UNITED STATES PATENT AND TRADEMARK OFFICE

Office Action Summary

10/670,625

TRIPLETT ET AL.

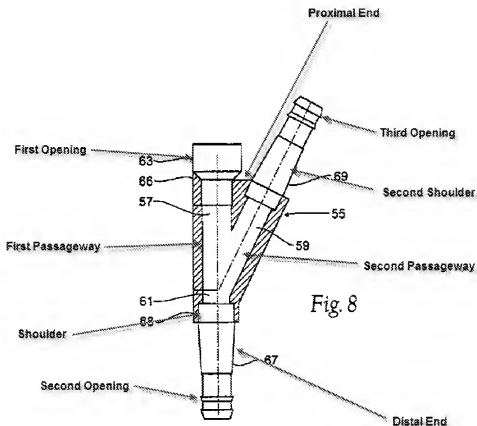
2. Claims 1, 2, and 4-7 are rejected under 35 U.S.C. 102(c) as being anticipated by U.S. Patent No. 6,969,379 to Aboul-Hosn et al.

Regarding claims 1, 2, and 4-7, Aboul-Hosn teaches a body, having a proximal end and distal end, comprising: a first passageway extending from a first opening to a second opening and configured to receive an inner lumen of a coaxial catheter; a shoulder on an outer surface of the distal end, positioned proximate the first opening, wherein the shoulder is configured to abut a wall of an outer lumen of a coaxial catheter; and a second passageway extending from the first passageway to a third opening (**refer to marked-up figure below**); wherein the second passageway forms an angle with the first passageway in the range of approximately 15 to 60 degrees (**refer to marked-up figure below**); wherein an outer surface distal of the shoulder is tapered (**refer to marked-up figure below**); wherein the first passageway has a smaller diameter proximal to the point at which the second passageway connects thereto (**refer to marked-up figure below**); wherein a diameter of the second passageway increases at a point adjacent the third opening (**refer to marked-up figure below. Also note that this is a very broad**

limitation); further comprising a second shoulder on an outer surface of the proximal end positioned proximate the third opening, wherein the second shoulder is configured to abut a wall of an extension tube (**refer to marked-up figure below**);

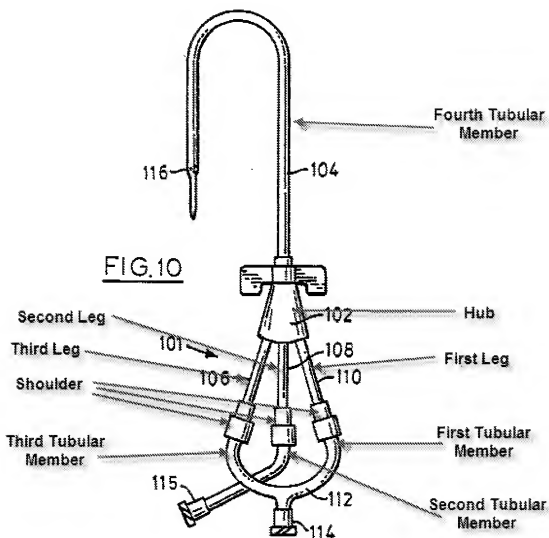
3. Claims 8-11, and 15-23 are rejected under 35 U.S.C. 102(b) as being anticipated by U.S. Patent No. 5,395,316 to Martin.

Regarding claims 8-11, and 15-23, Martin teaches a coaxial catheter comprising at least two lumens; at least two extension tubes; and an insert positioned between the catheter and the

tubes comprising: a body, having a proximal end and distal end, comprising: a first passageway extending from a first opening to a second opening and configured to receive an inner lumen of the coaxial catheter; a shoulder on an outer surface of the distal end, positioned proximate the first opening, wherein the shoulder is configured to abut a wall of an outer lumen of the coaxial catheter; and a second passageway extending from the first passageway to a third opening; wherein the inner lumen of the coaxial catheter is positioned within the first passageway of the body and the distal end of the body is positioned within the outer lumen of the coaxial catheter, the shoulder abutting a wall thereof; wherein a first of the extension leg tubes is connected to the inner lumen of the coaxial catheter and a second of the extension tubes is connected to the second opening of the body; further comprising a hub molded over a proximal end of the coaxial catheter and the body, wherein the body is completely encapsulated by the hub (**refer to figure 10 and column 5 line 52 – column 6 line 5**); a first generally tubular member; an insert including a first leg positioned in a proximal opening of the first member; a second generally tubular member positioned coaxially in a lumen of the first member and a first channel of the insert; and a hub disposed over the insert and a proximal end of the first member; the first leg extending from a distal end of the insert and terminating at a shoulder disposed on an outer surface of the insert; a surface of the first member proximal end contacting the shoulder; wherein the first leg has a tapered outer surface; the insert including a second channel in fluid communication with the first channel and the first member lumen; wherein a longitudinal axis of the second channel forms an angle with a longitudinal axis of the first channel in the range of about 15 degrees to about 60 degrees; further comprising a third generally tubular member having a distal end adjacent a first proximal insert opening, the third member in fluid

communication with the second member; further comprising a fourth generally tubular member, the insert including a second leg positioned in a distal opening of the fourth member; wherein the hub is disposed over the distal ends of the third and fourth members **(refer to marked-up figure below. Note that the examiner has specifically labeled the figure for the courtesy of clarification. Other constructions are possible from the labeled elements (i.e. first leg may be construed as second or third leg).**
